Comments and/or Proposals regarding to The Revision of GTR22

prepared by JAPAN

63rd EVE IWG

Regarding “EVE-61-13er1-GTR22 working draft v3 with meeting revisions.doc” , Japan follows EVE IWG decision but has comment and proposal

Part B : Verification of Battery Durability and Virtual Distance

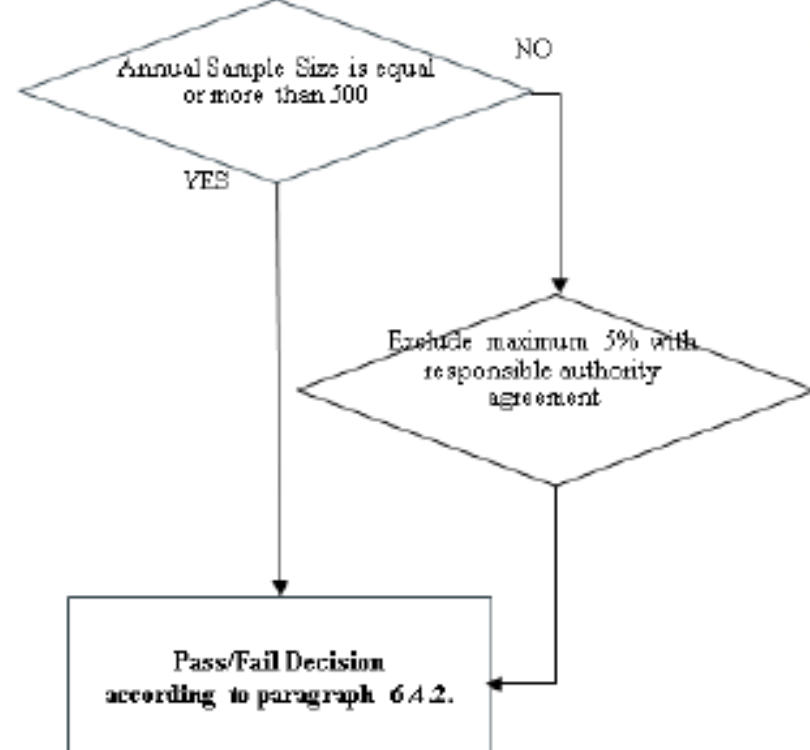
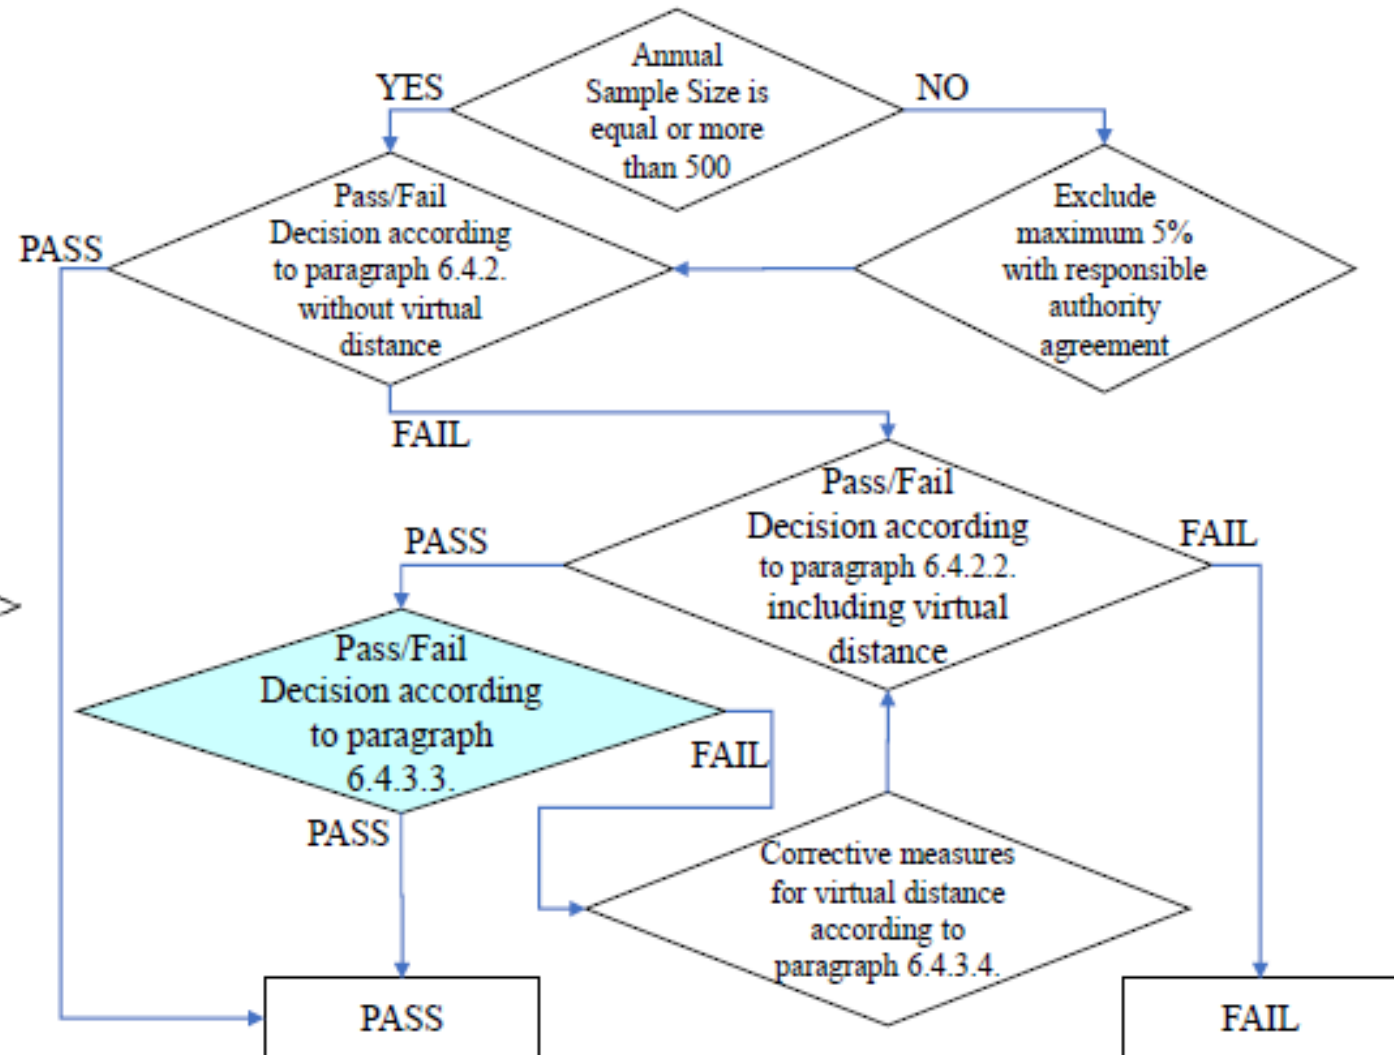
Proposals on On-board V2X (& PTO) Verification Method

1. General Process : please refer next slide
2. Concrete proposed text : please refer word document
“EVE-61-13er1 - GTR22 working draft v4_virtual distance”
with flow chart described in slide_7

verification process of virtual distance

Step 1.

Check each sample area (A, B and C)
with vehicle odometer

- If all sample areas comply with MPRs, the durability family shall PASS
- If at least one of sample areas does not comply with MPRs, move to **Step 2.**

Step 2.

Check the failed area(s) under the Step 1.
with odo. + virtual distance

- (a) If at least one of sample area(s) fail MPR(s), the durability family shall FAIL
- (b) If all area(s) comply with MPR(s), move to **Step 3.**

Step 3. “verification of virtual distance”

Verification area(s) shall be same area(s) as Step 2_(b).
In case of more than one area, no need to check by each area, but at least one vehicle shall be sampled from each area.
